TABS TI PLUS Inside Corner Detail over 2" to 3" Insulation

Revised Oct.28th 2026

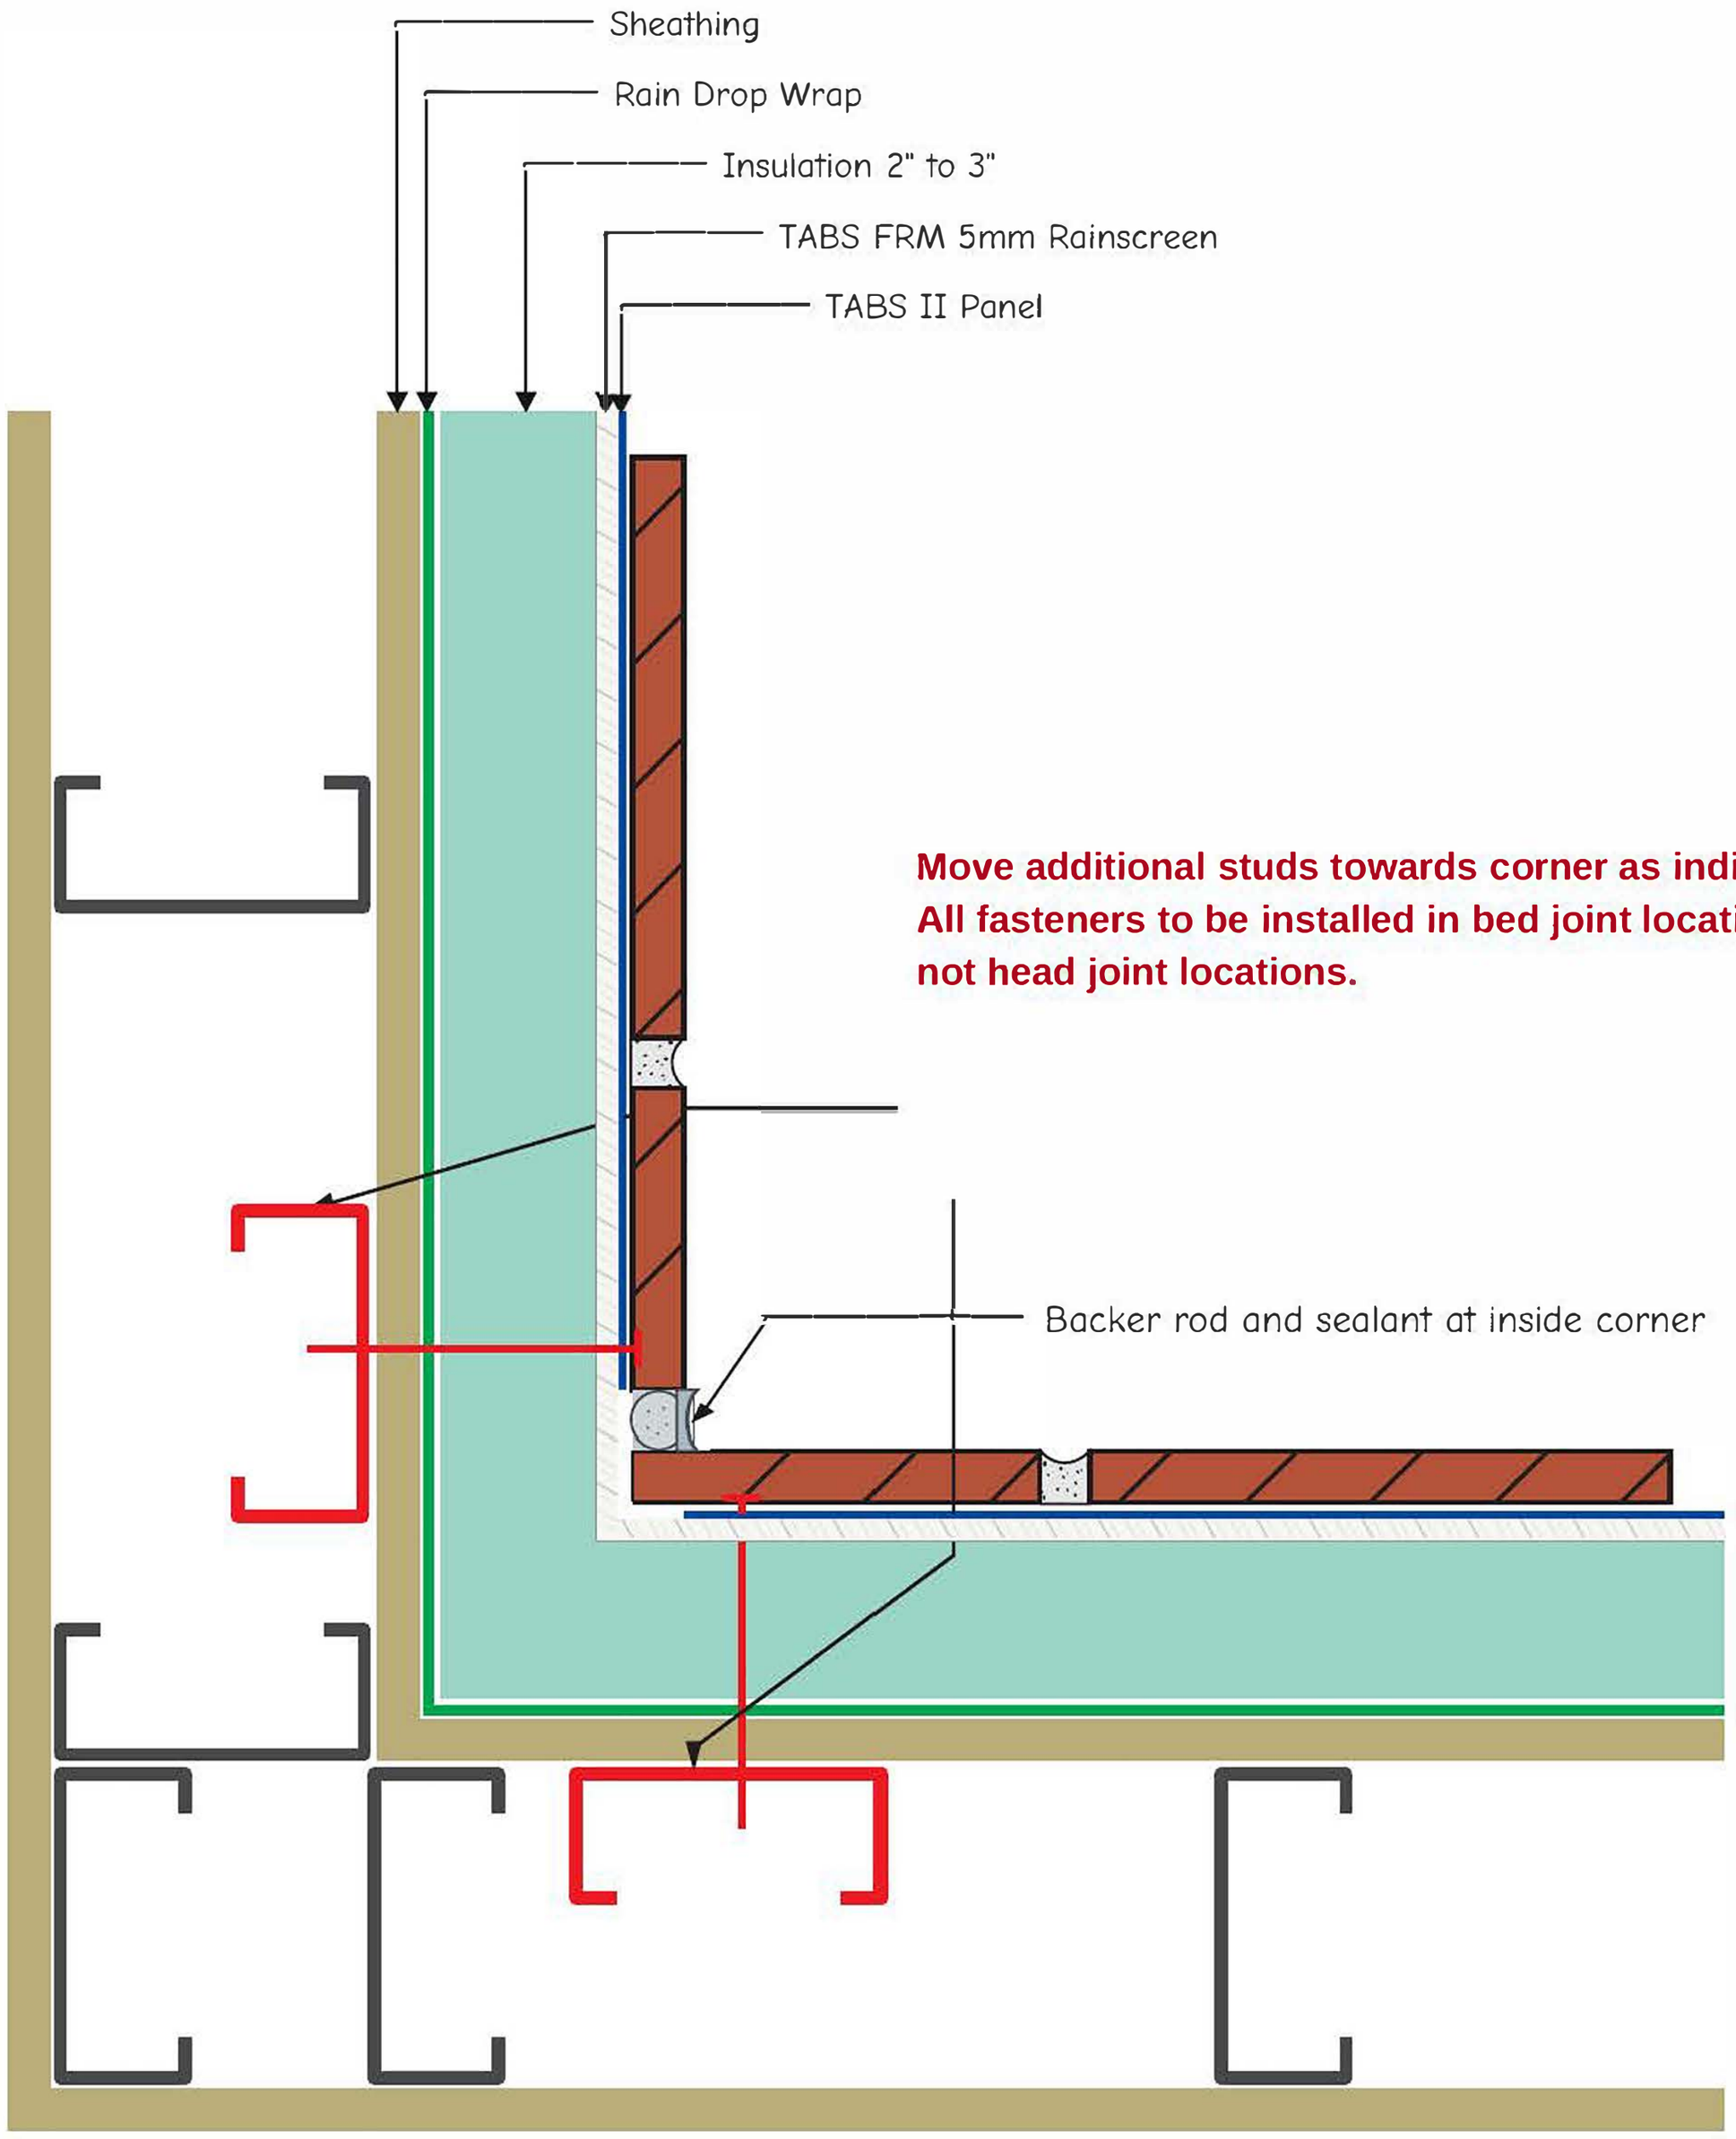
Move additional studs towards corner as indicated.
All fasteners to be installed in bed joint locations, not head joint locations.
